## Drifter Engine Mount Strut Bracket Defect

Advice of a defect on the engine mount support arrangement of a Strut Braced Drifter has been received with anecdotal comment that two other aircraft have had the same fault. This article is produced to require operators of Drifter aircraft to ensure integrity of the brackets which attach the vertical engine support column to the fuselage tube.

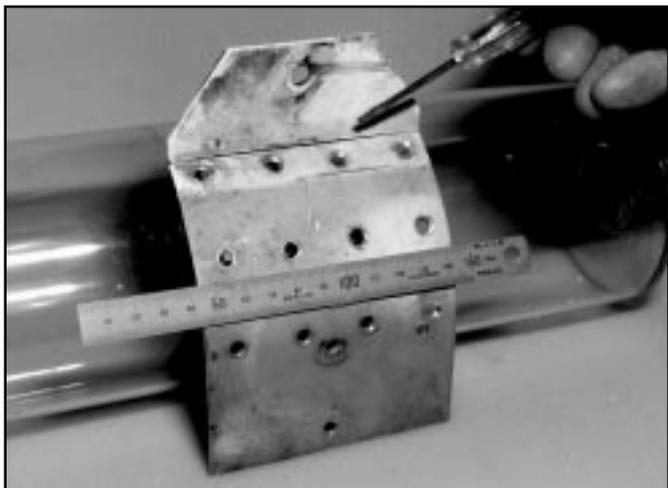
The item(s) in question are the two fittings which are located on the fuselage tube See figure below. (Note that they are partly covered by the floor pan).

1. All Drifters should be inspected before next flight to ensure there are no cracks in these fittings. The area is readily inspectable, can easily be inspected on a pre-flight and should be incorporated at least into daily inspections.
2. The initial inspection is to be recorded in the Aircraft Log Book.
3. All findings should be reported to the AUF

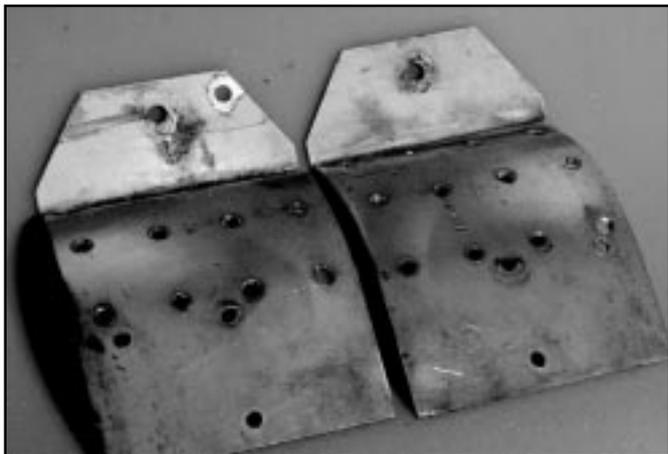
The brackets themselves are of formed sheet. They are curved to fit around the fuselage boom where they are riveted in place, and they are bent to form vertical lugs which fit either side of the engine support strut which is secured to them by a through bolt. The problem exists in the bend which forms the lugs as shown in the middle photograph. Both brackets failed along their full length.

Note too that there had been other failures in each of the brackets as shown in Figures 6 and 7.

Note that all reports applied to Strut Braced Drifters only and the brackets that failed seemed to have little or no radius at all at the bend. Wayne Fisher of Spectrum Aviation in Lismore advises that he has Maxair drawings of the parts used at this location in Maxair Drifters and that these drawings specify a minimum inside radius at the bend of 1/8 inch. He also notes that the drawing requires that the grain of the material should run across the bend, not parallel to it.

It would appear that the failed brackets notified to date have occurred on the Austflight Strut Braced Drifters and that those brackets do not have the radius.
